AGENDA
PLANNING AND ZONING COMMISSION MEETING
CITY OF CREVE COEUR, MISSOURI
MONDAY, SEPTEMBER 21, 2020

1. PUBLIC HEARING. Application #20-026: Amended Conditional Use Permit and Site Development Plan for Courtyard by Marriott at 828 N. New Ballas Road, Creve Coeur, MO 63141

APPLICATION TO PLANNING AND ZONING COMMISSION
#20-026: AMENDED CONDITIONAL USE PERMIT AND SITE
DEVELOPMENT PLAN FOR COURTYARD MARRIOTT AT 828 N. NEW
BALLAS ROAD, CREVE COEUR, MO 63141

Figure 10: Google images of the non-conforming bulb lights at the entrances to the site.

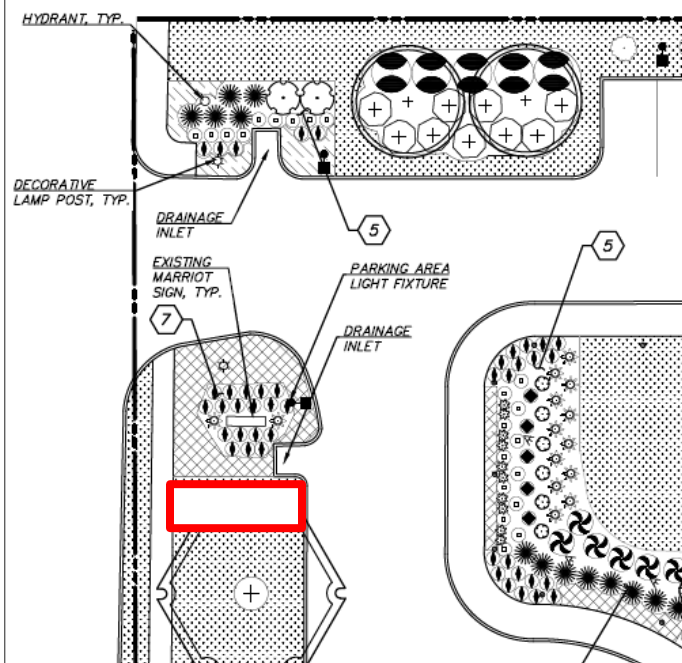
405.680 Lighting, as they are not downcast and fully shielded. Therefore, Staff has included a condition that these lights should be replaced, if needed, to comply with the zoning regulations.

Figure 3: Close-up of the Applicants Landscape Plan from 2018.

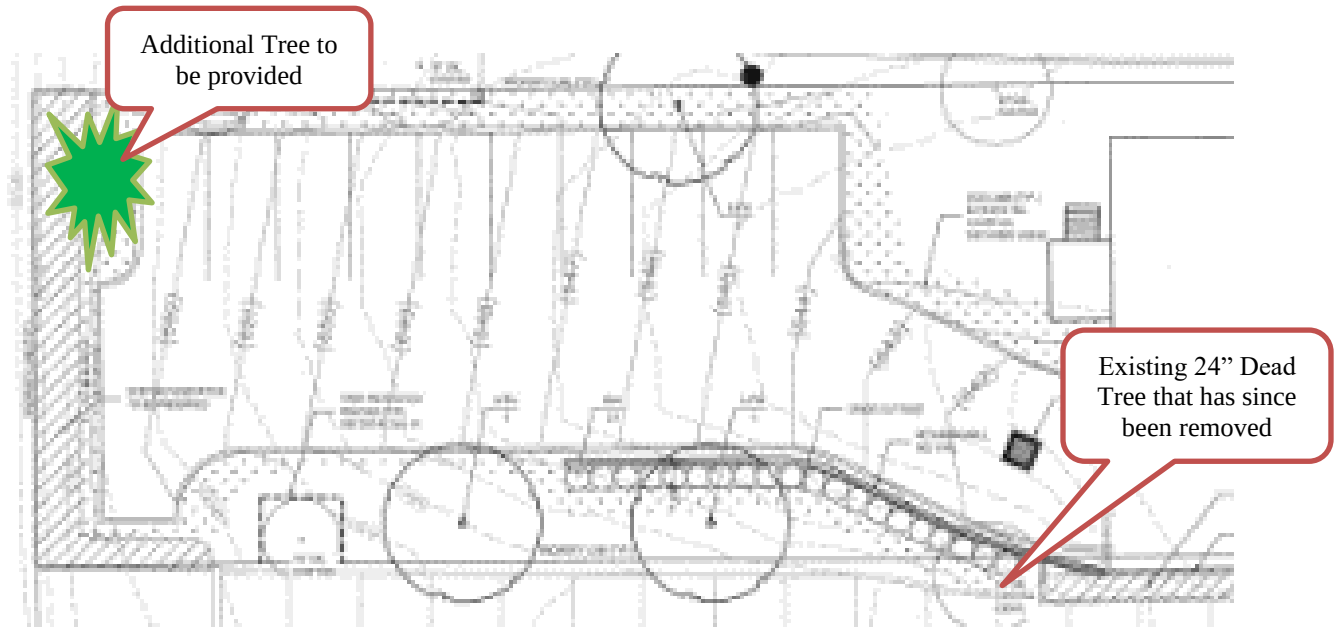
As stated above, the proposal includes one row of 10 parking spaces. The 2018 Landscape Plan indicates that 3 new trees were to be provided, and Staff recommended that an additional tree be provided at the back end of the parking row to meet with the requirements of this section. There is an existing large 24" tree north east of the proposed parking that should provide sufficient shade. The Applicant did not provide a revised landscape plan. Therefore, Staff recommends that the 2018 Landscape Plan should be followed, and with the four new trees to be provided, at a minimum of 3" caliper, per Section 405.540(F). Additionally, all landscaping is to be maintained per the approved plans, with an underground irrigation system. The Applicant has provided the agreement from a landscape company to provide for the underground irrigation.

A perimeter landscaped buffer of 5 feet is provided with the new area, as required by Section 405.540(F)(12); however, the existing drive aisle, does encroach into the adjacent property, and the connecting retaining will require the adjacent property owner's approval, prior to the issuance of the site improvement permit and building permit for the work.

Figure 4: Detail of Site Development Plan of the Typical Retaining Wall Section

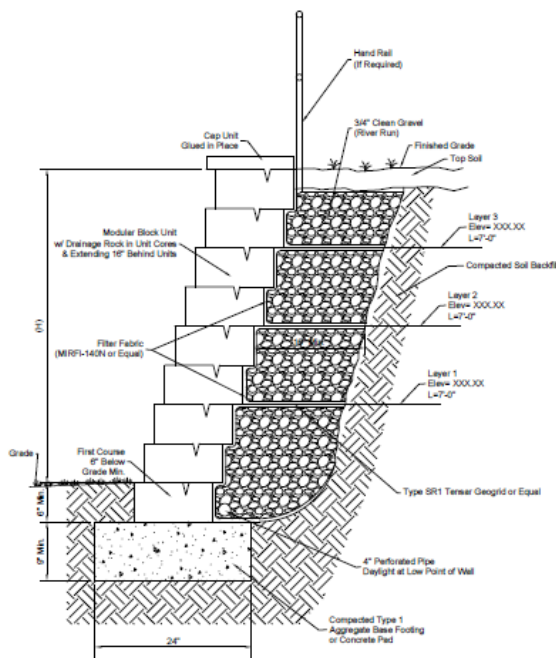
The proposal does include a retaining wall, and a fence if one is required. A building permit is required for any retaining wall over 24 inches in height. The typical retaining wall detail is showing approximately 4 feet. The City's Design Guidelines recommend that retaining walls should be screened with appropriate landscaping and designed to incorporate elements of other architectural features or natural features of the project. Color samples of the block wall have not been provided. Given the location and the character of the existing development of a former home, and the existing blocks along the driveway are a grey color, Staff does not have a concern regarding the use of a typical grey color in this setting. The 2018 Landscape Plan did include plantings on top of the wall, and a condition that this should be carried with the approval has been included. The Building Code may require a safety barrier along the top of the retaining wall, if required, Staff has included a condition that this shall be a black open-slatted, wrought iron style design.

Figure 5: Close-up of the site plan showing the existing accessible parking space.

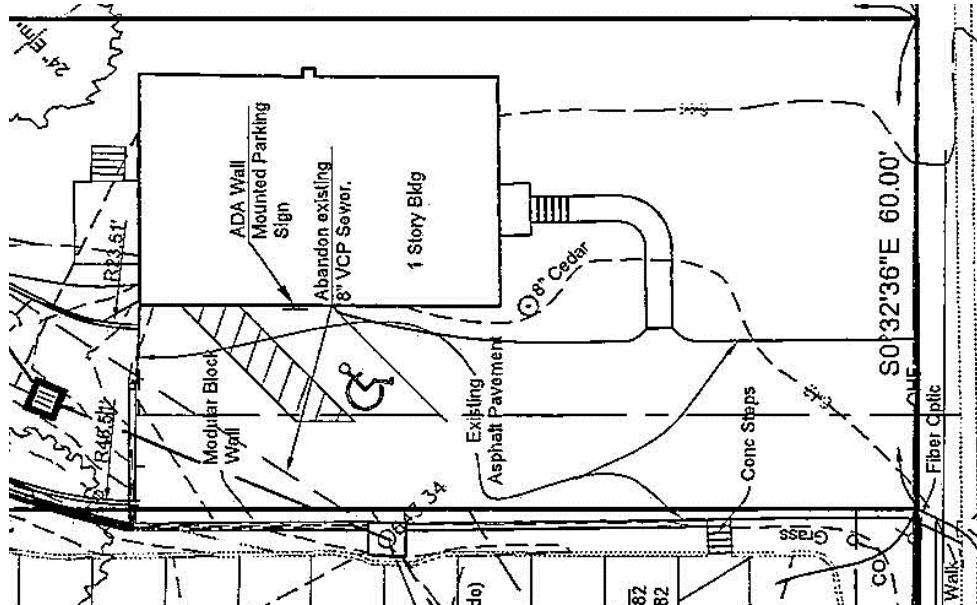
With the additional 10 parking spaces provided, the Building Code requires that at least one of the spaces is made van accessible. The Applicant has indicated that the existing one accessible space is adjacent to the building and the revised site plan emailed on March 21 shows this area. However, the space looks like it would block a portion of the drive aisle. Section 405.810(A)(1) requires a minimum of 22 feet for drive aisles. Therefore, Staff has included a condition that this space may need to be reworked or made to be a parallel space to provide sufficient passing of vehicles. If the space is required to be located into the new parking area, adequate pedestrian access will need to be included.

Figure 3: Close-up of the Applicants Landscape Plan.

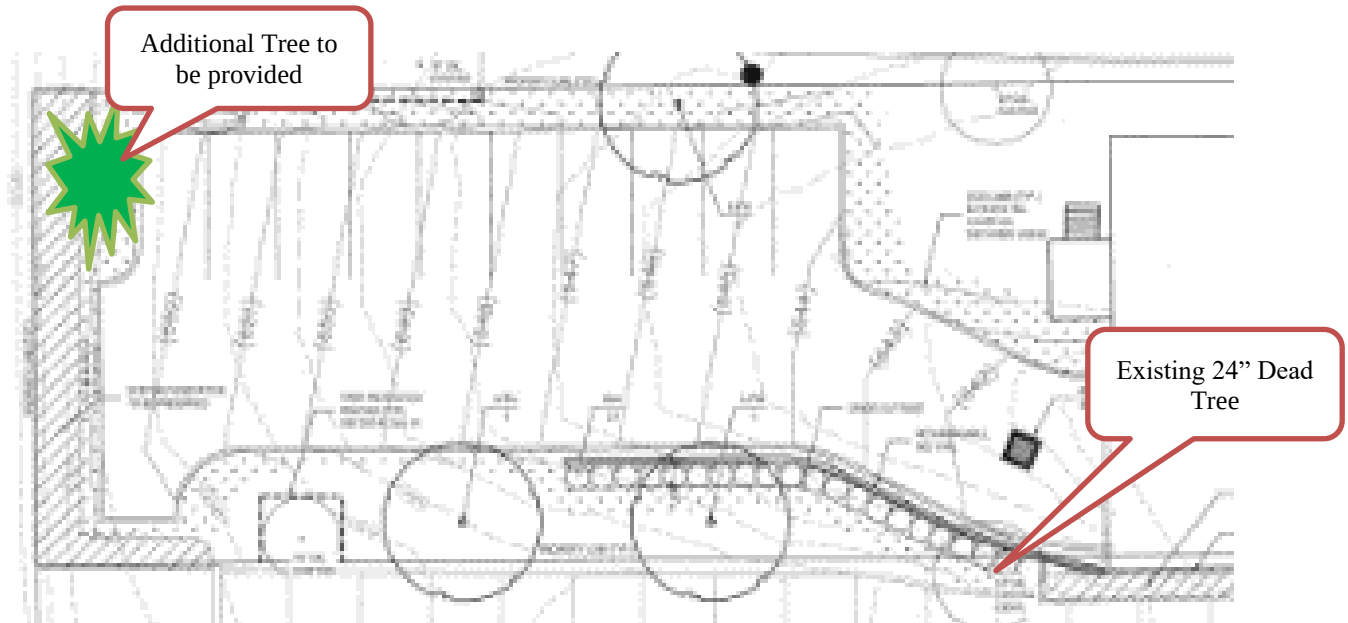
As stated above, the proposal includes one row of 10 parking spaces. The Landscape Plan indicates that 3 new trees are to be provided. However, Staff recommends that an additional tree be provided at the back end of the parking row to meet with the requirements of this section. There is an existing large 24" tree north east of the proposed parking that should provide sufficient shade. The plan also indicates that just off the property line there is an existing 24" dead tree. The construction of the retaining wall will have a further negative impact and this tree should be removed. Staff recommends that the Applicant work with the property owner to the south to have this tree removed and replaced.

The plans also indicate that the Trees a 2.5 inch caliper, where Section 405.540(F) requires a minimum of 3" caliper. Additionally, all landscaping is to be maintained per the approved plans, with an underground irrigation system.

Figure 4: Close-up of the site plan showing the existing accessible parking space.

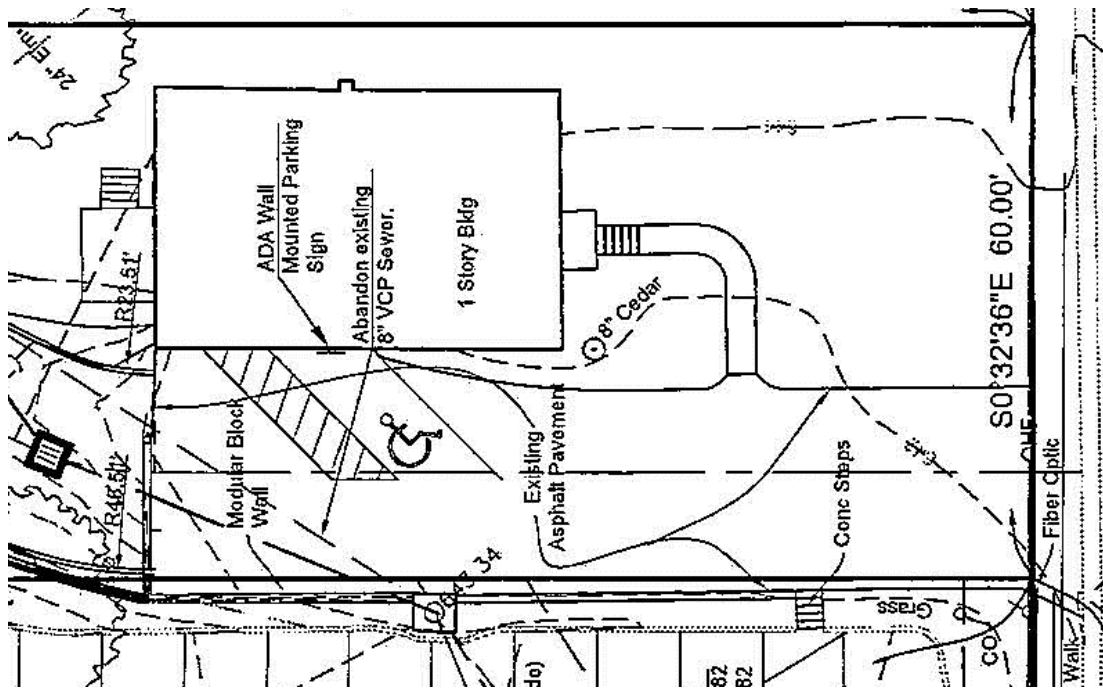
With the additional 10 parking spaces provided, the Building Code requires that at least one of the spaces is made van accessible. The Applicant has indicated that the existing one accessible space is adjacent to the building and the revised site plan emailed on March 21 shows this area. However, the space looks like it would block a portion of the drive aisle. Section 405.810(A)(1) requires a minimum of 22 feet for drive aisles. Therefore, Staff has included a condition that this space may need to be reworked or made to be a parallel space to provide sufficient passing of vehicles. If the space is required to be located into the new parking area, adequate pedestrian access will need to be included.
